The U.S. Department of Energy (DOE) requested the U.S. Environmental Protection Agency conduct a review of the July 2018 "pre-published" *Technical Memorandum-1* report (TM-1). This document presents results of a recently completed geological/hydrological characterization assessment of the Bear Creek Valley Site 7c location for the proposed Environmental Management Disposal Facility.

EPA Comments on Technical Memorandum #1, Environmental Management Disposal Facility Phase 1 Field Sampling Results, Oak Ridge, Tennessee

Figure 1. Spot Check Comparisons of GW-992R and GW-993 Water Levels

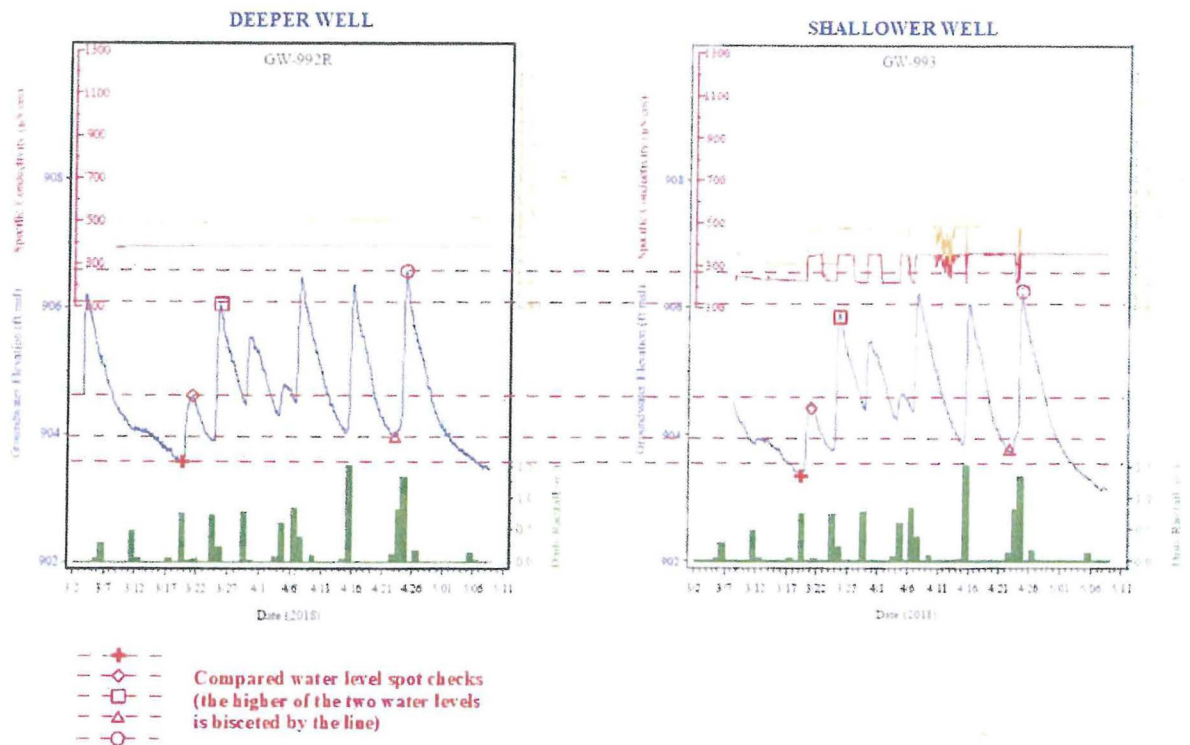
2. Table 6.4 presents “Vertical gradient direction, Spring 2018” values for each of the eight shallower/deeper well pairs. There is obviously some basis for developing an overall average based on the limited-duration data set. The means of reaching the overall Table 6.4 conclusion needs to be described in the Tech Memo. For the GW-992R/GW-993 and GW-982/GW-983 well pairs, Table 6.4 indicates there is no overall vertical gradient direction. A series of spot checks of Figure 6.6 and Figure 6.9 (figures showing the water levels for these well pairs) indicates that at numerous times over the early-March to early May period of water level monitoring of this well, the deeper of the GW-992R/GW-993 wells had a higher water level than the shallower well (see Figure 1 below) while at GW-982 and GW-983, the shallower well typically had the higher water level (see Figure 2 below). These water-level relationships are consistent with the overall conceptual model of groundwater flow (downward vertical gradient component in upslope recharge areas; upward vertical component in downgradient discharge areas). The conclusions reached should be better explained within the context of the seasonality of changing water levels in these wells. As presented the conclusions are misleading. Correct to reflect the varying nature of the wells by adding another column (or two) indicating a different time and a different hydraulic gradient.
